MCKB-Ø32 Change Notification

MCKB-Ø32

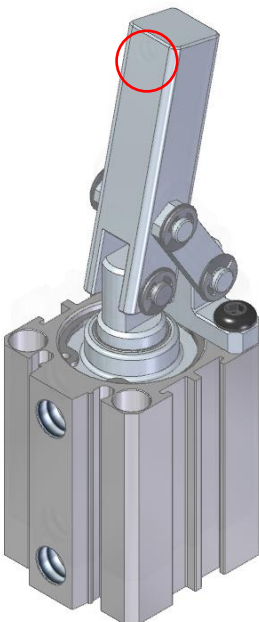
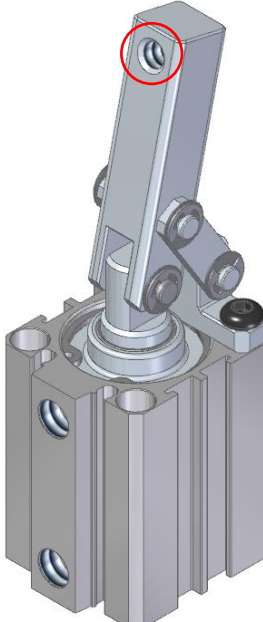
Before	After
The lever has no hole on it. 	The lever has a new threaded hole.
